Welcome to The 2016 Series of CoPC Mapping Discussions

DRAFT Preliminary Remedial Action Plan

Summary of Point by Point Technical Issues in CPG Response

Relative Change in SWAC vs. Percentage Area Remediated

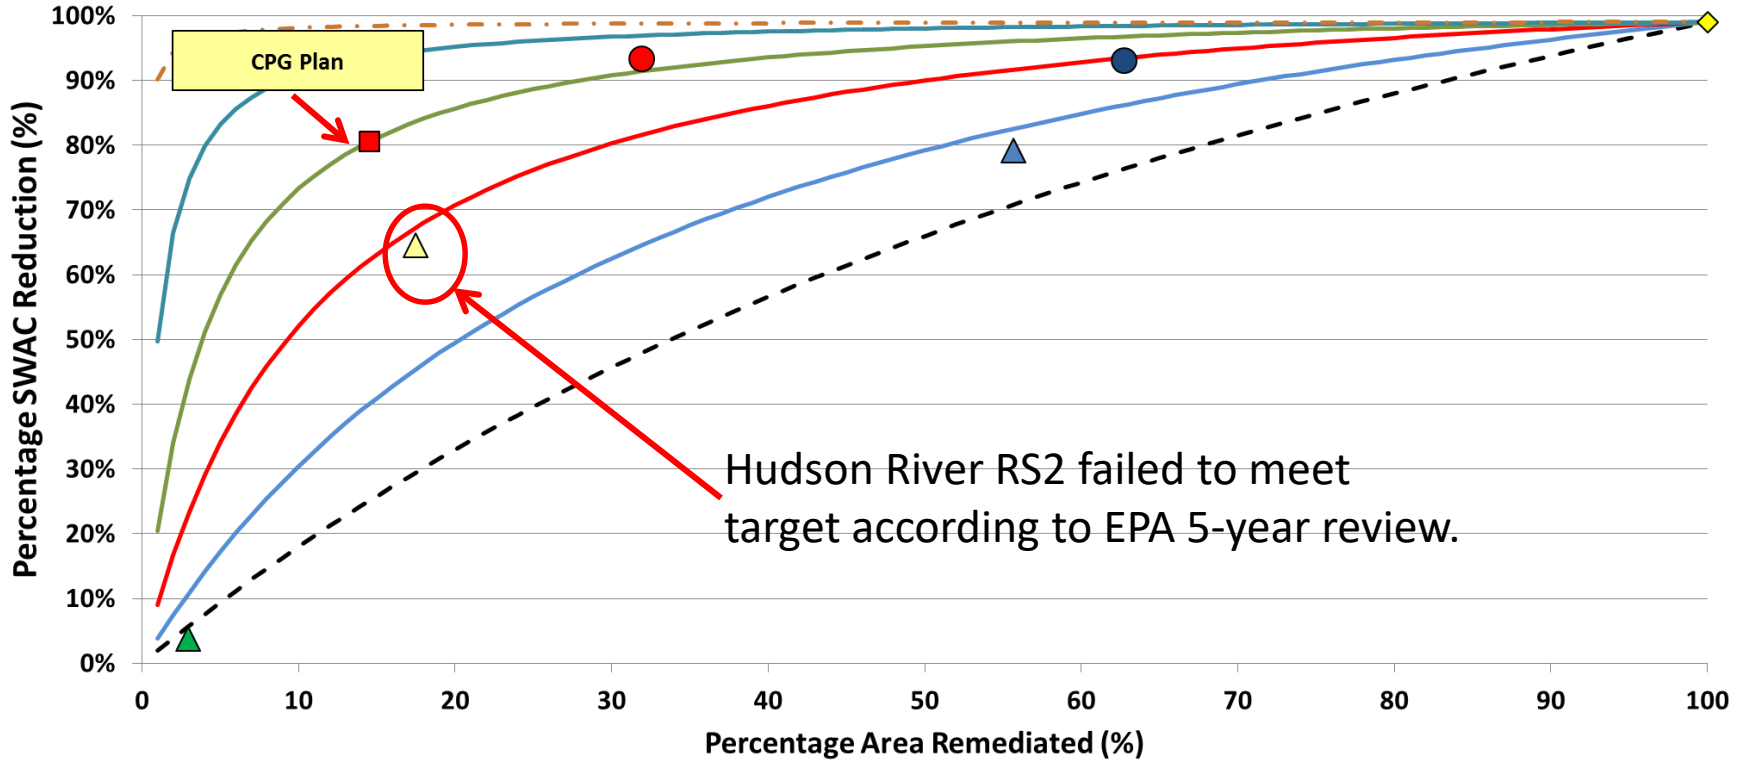
The curves shown in Figure 2 of the Region 2 White Paper are of little practical value and are used to incorrectly imply that the ratio of the average concentration in remediated to un-remediated areas is 26:1 throughout the river. That is not the case; approximately half of the target areas have ratios less than 10:1.

- The white paper does not suggest that the ratio *is* 26:1, but rather that to achieve 81% reduction with a 15% remedial footprint the ratio *must be at least* 26:1. Any lower ratio will preclude achieving the CPGs targeted level of reduction.
- The EPA agrees with CPG that achieving a 26:1 ratio is highly unlikely and therefore a substantively larger remedial footprint is necessary to achieve 81% reduction.
- Experience at other sites suggest that achieving 81% reduction would require remediation of 30% to 60% of surface area.

Figure 3-6
Comparison of RI Dataset and RI Dataset with RM 10.9 Design Data Interpolations
Contaminant Mapping Response
Lower Passaic River Study Area Remedial Investigation/Feasibility Study

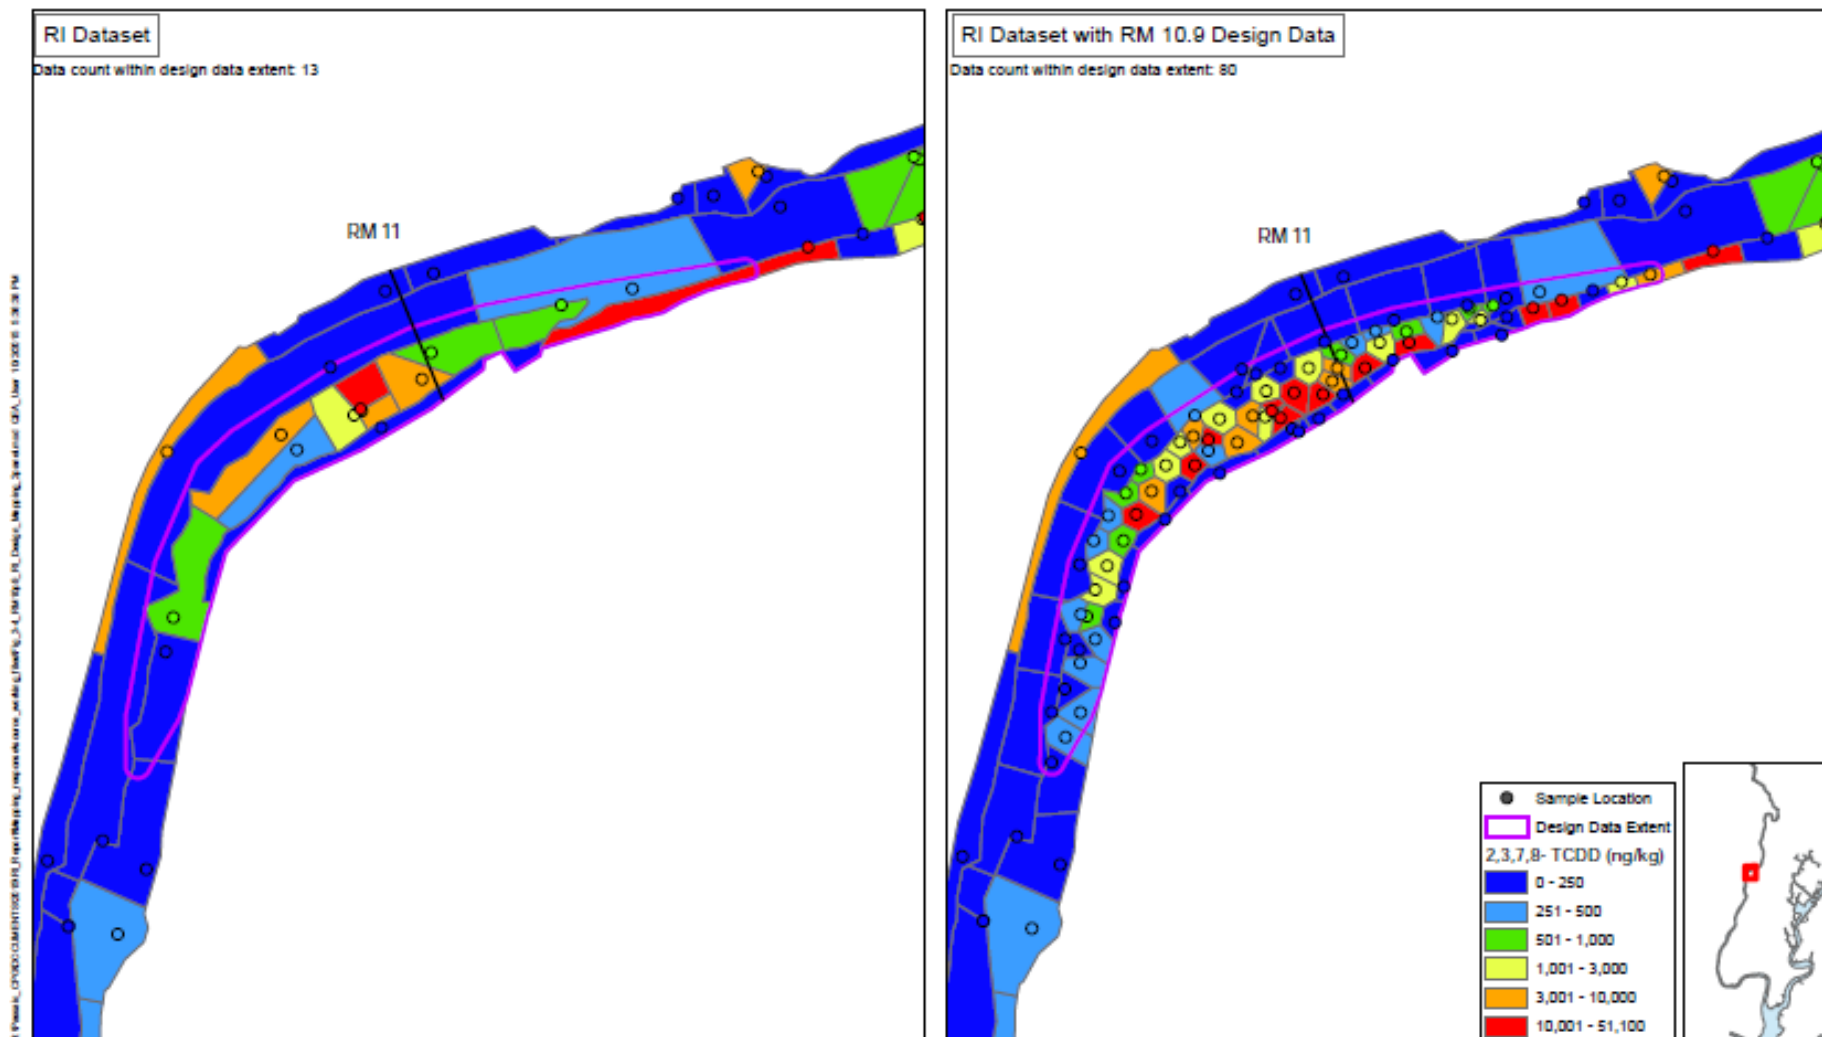
Two aspects of Region 2's test invalidate its conclusions: 1) it considers an area that extends far beyond the region where design scale data exist (Figure 3-4); and 2) it does not test the map presented in the Draft 17-mile RI Report; rather it tests a cruder map generated using only a portion of the RI data.

The analysis should consider only the 13-acre area where high density data were collected.

- EPA analysis evaluated the accuracy of the SWAC vs RAL calculation using RI data density (0.5 samples per acre) in and around RM10.9. This was a test of the CPG calculation procedure.
- The CPGs suggestion to work with the 13 acre design data extent, would provide a test of the mean of $N=13$ and $N=80$ samples conditional on a pre-specified area.
- This is not how the CPGs SWAC vs RAL calculation was performed and therefore would not provide a test of the relationship.

Use of SSP2 data to validate CPGs model

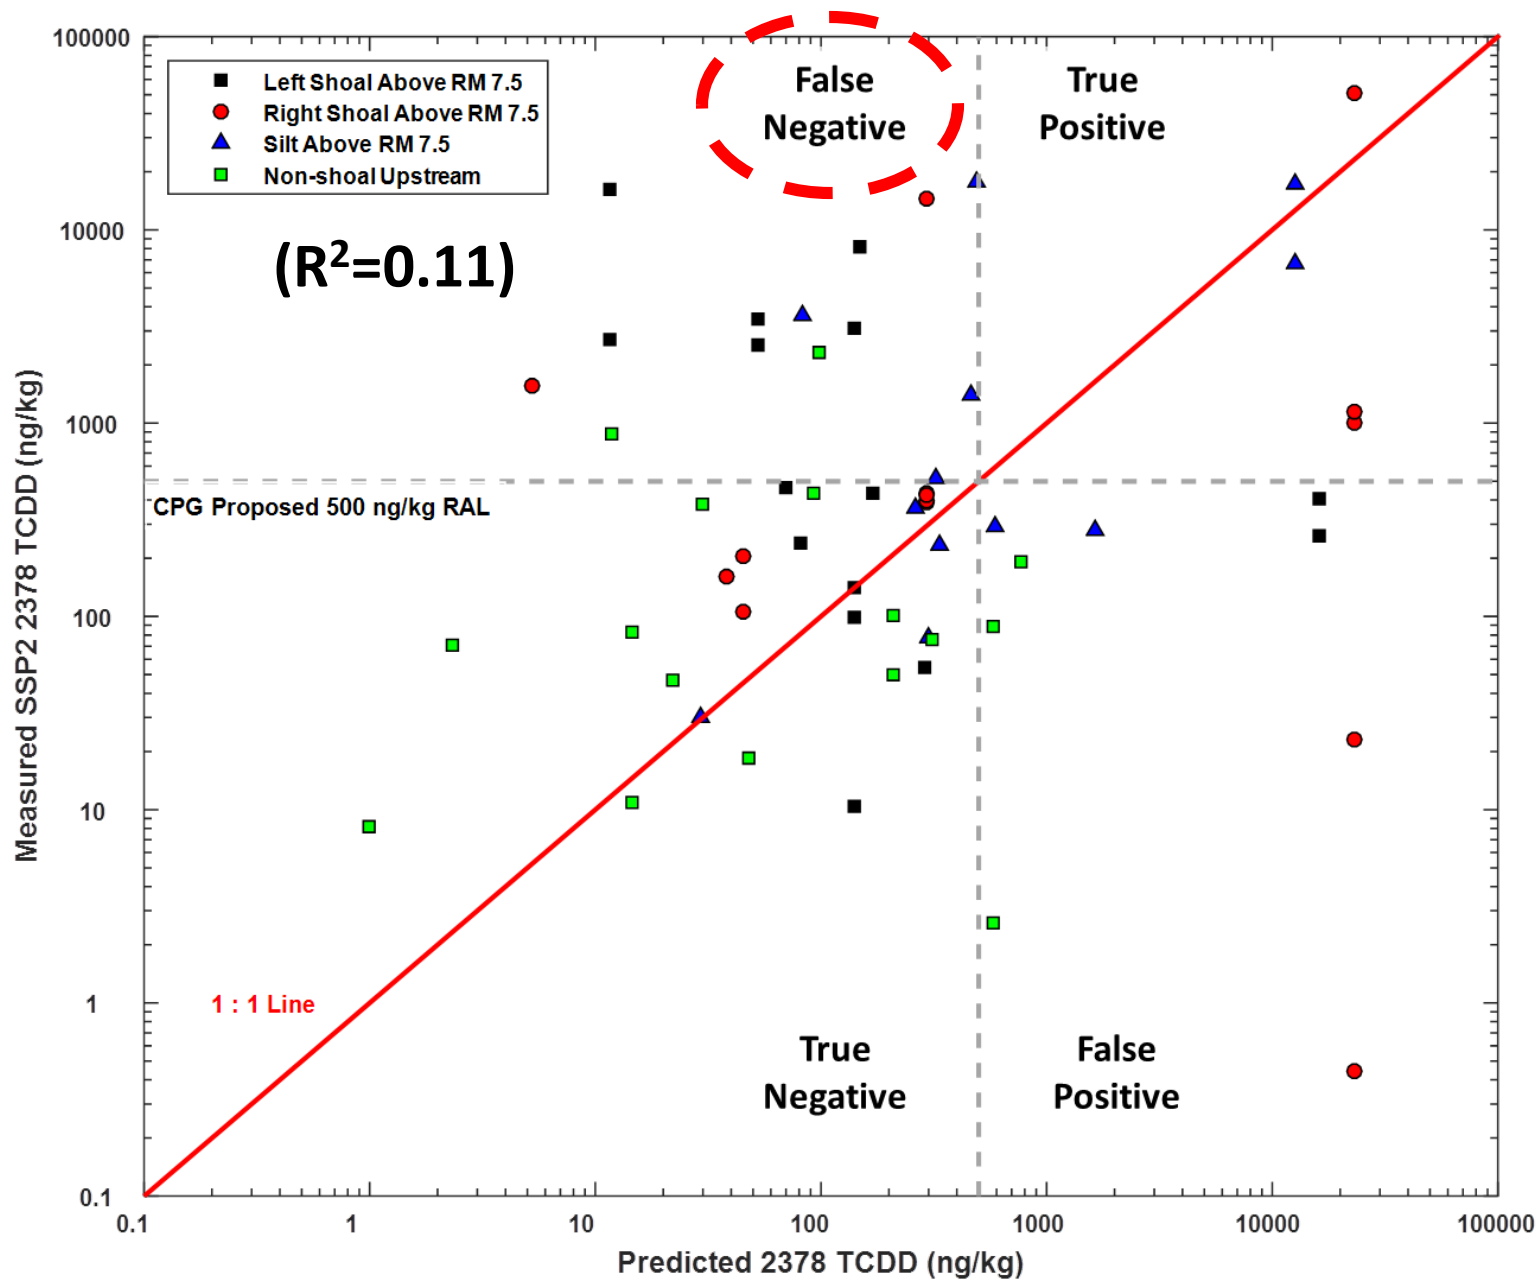
For example, SSP2 samples were sited to address concern with mapped high concentrations in sediment identified as coarse in side scan sonar. These high concentrations were from finer sediments found within a generally coarse area. Anticipating that they were finer pockets not characteristic of the coarse deposit, samples were collected in SSP2 to bound the extent of elevated concentrations. Therefore, finding lower concentrations is no surprise and consistent with the system understanding. The samples were not collected with the expectation of confirming the high concentration polygon.

- DQO 1 – Provide additional characterization of the nature and extent of sediment chemistry and fill data needs above RM 8, **as identified by USEPA.**
- EPA found more of a problem with higher concentrations where low concentrations were predicted (False Negatives).
- Some samples may have been in areas where prediction is difficult, but one should not expect correlation to be completely absent ($R^2=0.11$).

Statistical Simulation

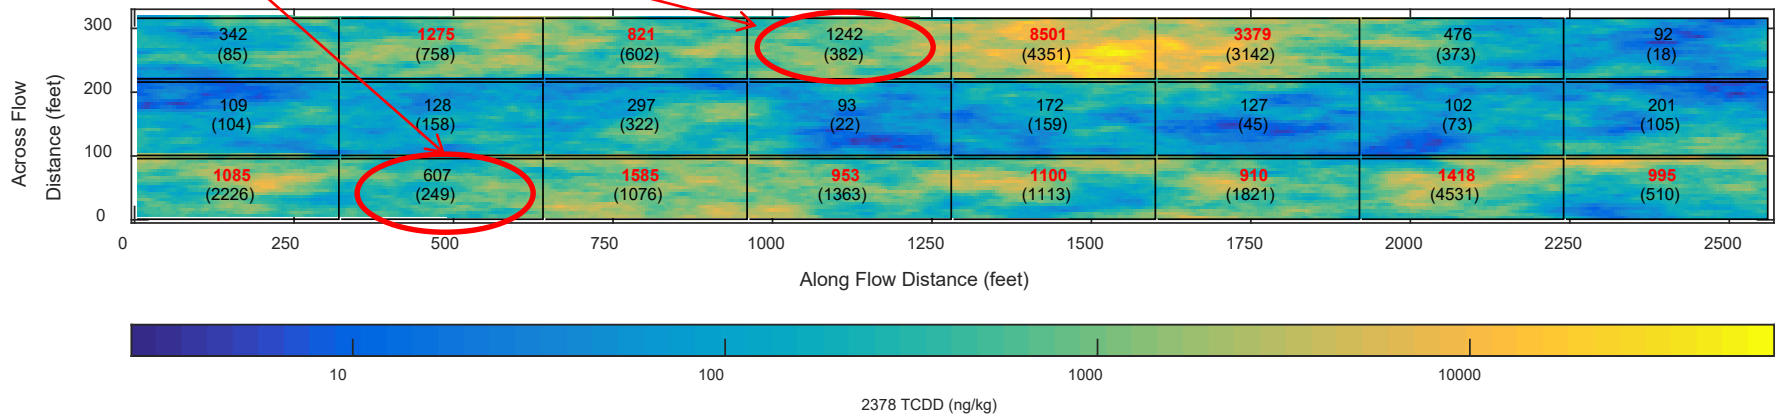
Region 2's statistical simulation ignores the basic characteristic of a targeted remedy by defining target and non-target areas using decision units much greater than the area over which concentrations are correlated, thus including regions of low and high concentrations.

- The simulation follows the CPG SWAC vs RAL calculation identically
- The report included 2 simulation runs with range of influence approximately equal to the distance between adjacent samples (201 feet,) and substantially longer range of influence (320 feet).
- In many areas the distances between nearest RI samples are greater than the range of influence estimated by CPG.
- The simulations were re-run with the rectangular decision units corresponding exactly to the Thiessen polygons as with the CPG procedure, and with range of influence three times the distance between adjacent samples (Much stronger spatial correlation than observed at LPR)
 - Results are not substantively different
 - Reduction in SWAC is overstated
 - Footprint size remains understated
